Model	Model Code	Model Type
BF175A	BAJJ,BAKJ	
BF200A	BAEJ,BAFJ	
BF225A	BAGJ,BAHJ

Authorized by Takashi Ishii
Power Product Service Engineering Department, Honda Motor Co.,Ltd

Final TBAB01 Warranty extension

Warranty Extension: O2 Sensor Failure

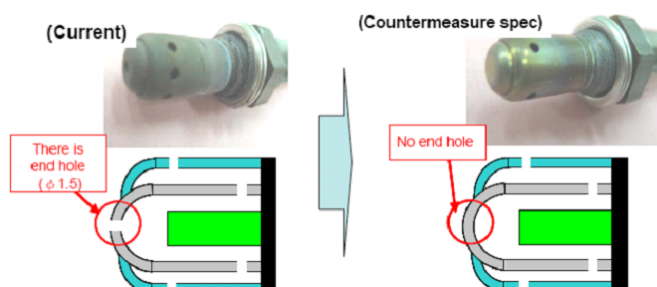
Symptom

Indicator light comes on and warning buzzer sounds intermittently at idle speed.

Causes

Protector exhaust introduction hole at end was leading directly to element, so sea water mist enters directly into sensor element, leading to rapid decrease of element temperature and O2 sensor element cracked.

Countermeasure

By changing exhaust gas introduction hole spec, reduce sea water inflow, to improve crack toughness at time exposure to water.

Current spec	Countermeasure spec
End hole		φ 1.5 x 1	Disused
Side holes	External protector	φ 1.5 x 8	φ 1.5 x 4
	Internal protector	φ 1.5 x 8	φ 1.5 x 4

<Identification of new C/M O2 sensor>

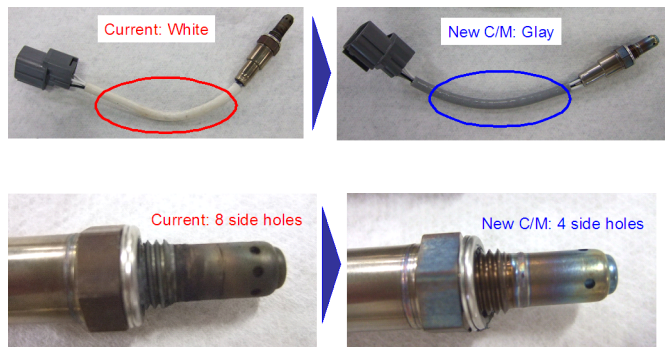
Parts Information
